# UNITED STATES PATENT AND TRADEMARK OFFICE

<b>Office Action Summary</b>	<b>Application No.</b> 10/527,967	<b>Applicant(s)</b> AMBROSI, JOHANN	
	<b>Examiner</b> JAY R. RIPLEY	<b>Art Unit</b> 3679

### **DETAILED ACTION**

(Horimoto Figure 10)

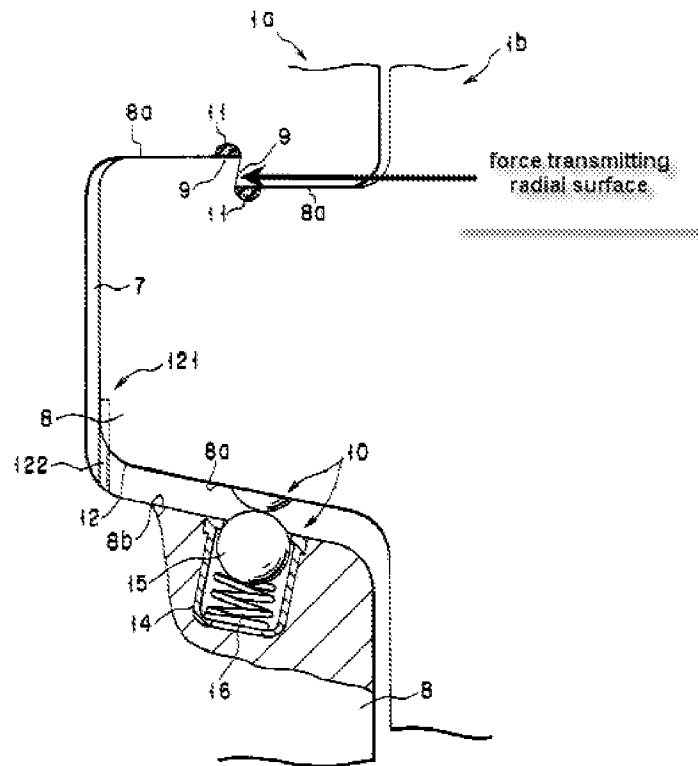
In regard to claim 6, Horimoto discloses in Figure 10 and Figure 19, the figures shown below, a symmetrical hose coupling comprising

a pair of like coupling members (1a and 1b, as observed in Figure 19, below),  
each of the coupling members having a cylindrical hose attachment connector (4) and a cam ring integrally formed with the cylindrical hose attachment connector (as observed in Figure 19, below - the Examiner notes that the phrase "integrally formed" embraces united constructions constituting a unitary whole), the connector having at least one outside diameter (the connector of Horimoto has numerous "outside"

the cam ring having a plurality of integral cams (8) arranged on the periphery of the cam ring and projecting from the cam ring (the slots noted in Figure 19, below and in Attachment A, result in the cams projecting radially from the cam ring - the blocking means appears to be positioned by the slots - note that the slots "bottom", radially inner surface, is the outer radial surface of the cam ring), the cams projecting radially beyond the largest outside diameter of the cylindrical hose attachment connector (the largest outside diameter of the cylindrical hose attachment connector" of Horimoto would be at the dotted line indicating the demarcation between "cam ring" and "hose attachment connector" in marked Figure 19, below) for defining the largest outside diameter of the coupling (the Examiner notes that the "blocking means" shown in Figure 19, below, is a part added onto the coupling of Horimoto and, as such, is not a required part of the coupling nor is the "blocking means" a requirement of the instant claim), the cams being hook-shaped in a tangential direction of the cam ring and each having a radial surface area (9 in Figure 10, below) for transmitting an axial force, and the cams of the coupling members engaging into each other during coupling such that the radial surface areas engage behind each other (the coupling members engage each other in the recited fashion as indicated in column 13, lines 19-34).

In regard to claim 7, Horimoto further discloses that the radial surface areas of the cams are inclined in relation to the tangential direction (column 8, lines 26-30, and observed in Figure 10, above).

(Horimoto Figure 19)

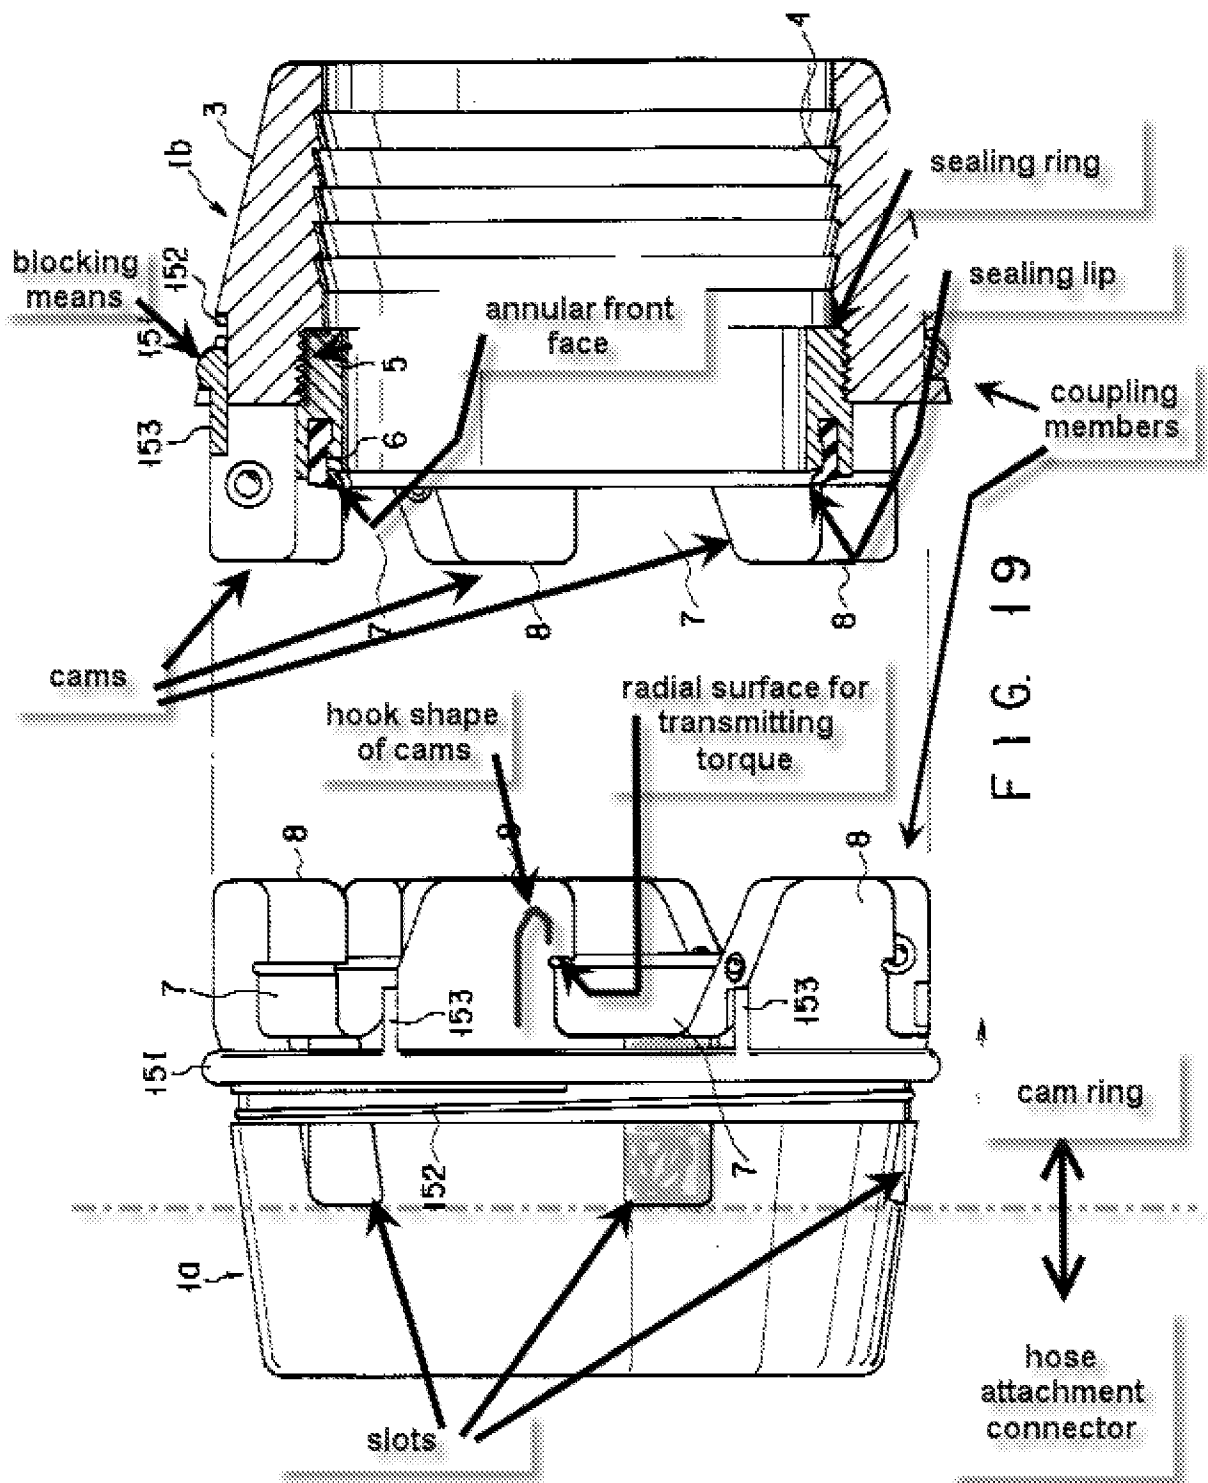
diameters, and as such, the Examiner arbitrarily chooses the "outside diameter" directly adjoining the "slots" noted in Horimoto Figure 19, shown below),

In regard to claim 10, Horimoto discloses the claimed invention in the embodiment as shown in Figure 19, above, with the exception of a blocking means that

does not project radially beyond the cams. The Examiner notes that Horimoto does disclose that a blocking means (lock claws 153 as observed in Figure 19, above, and as disclosed in column 13, lines 19-34) is provided for locking the pair of coupling members with each other in a coupled condition; however, the disclosed blocking means of the embodiment shown in Figure 19 projects radially beyond the cams. Horimoto teaches an alternative blocking means in Horimoto Figures 9-14 (taught starting in column 9, paragraph 2, through column 12, first paragraph) which does not project radially beyond the cams. It would have been obvious to one having ordinary skill in the art at the time the invention was made to simply exchange the blocking means as disclosed by Horimoto in the embodiment shown in Figure 19 with the blocking means as taught by Horimoto in relation to Figures 9-14 since they are functional equivalents.

(close-up of Horimoto Figure 19)

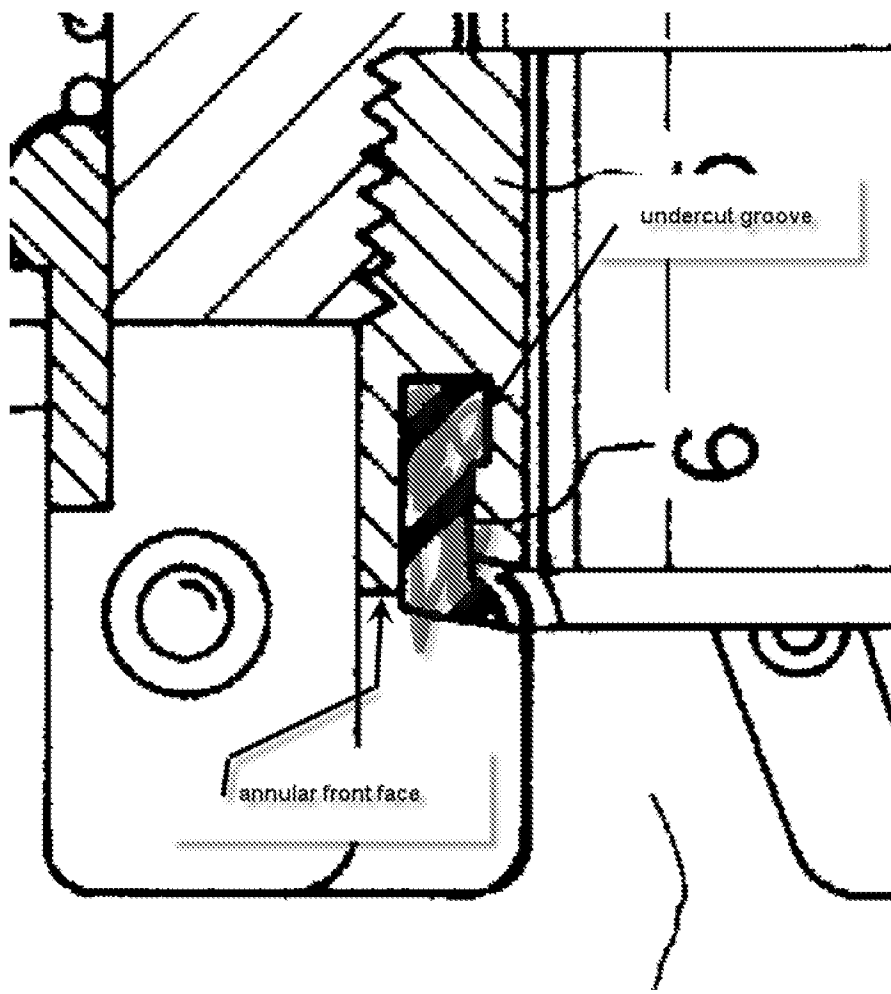
In regard to claim 8, Horimoto further discloses, in Figure 19, above, and close-up of Figure 19, below, that the cam ring has an annular front face radially inwardly of the cams and an annular undercut groove is recessed in the annular front face for receiving a shaped sealing ring having a sealing lip which protrudes axially beyond the front face of the cam ring.
